### Subject: T40093/5 RECALL – Inspection Needed

Number: VSE-20-10

Date: August 7, 2020

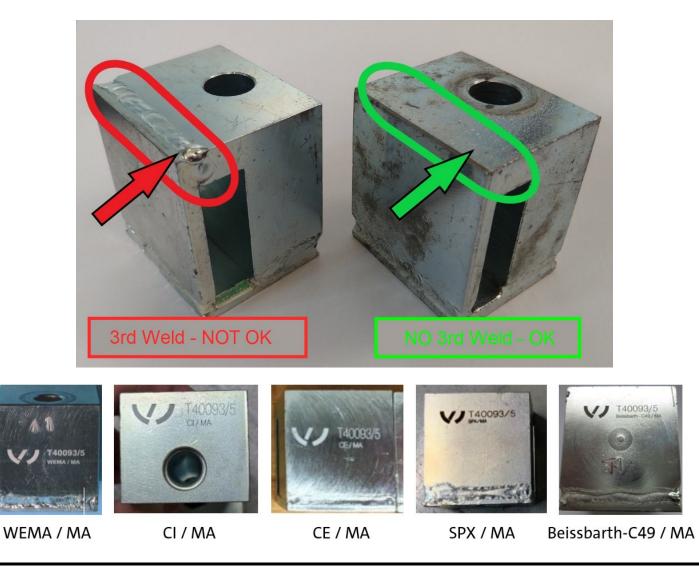
In the event of a complete malfunction of the T40093/5, the engine supported with T40093/5 will fall. Consequently, service personnel may sustain injuries and damage to the vehicle may occur. If the T40093/5 has the **third weld**, Please **DISCONTINUE USE IMMEDIATELY!** Set aside the effected T40093/5 for return and replacement.

## The presence of a third weld indicates replacement is needed.

Please identify if your T40093/5 has the third weld as shown below, and identify as one of the following manufactures.

T40093/5 is a component unit for the sets T40093, T40093A and T40093B, as well as individually as a replacement part. T40093/5 has been superseded by the new development T40093/5**A**.
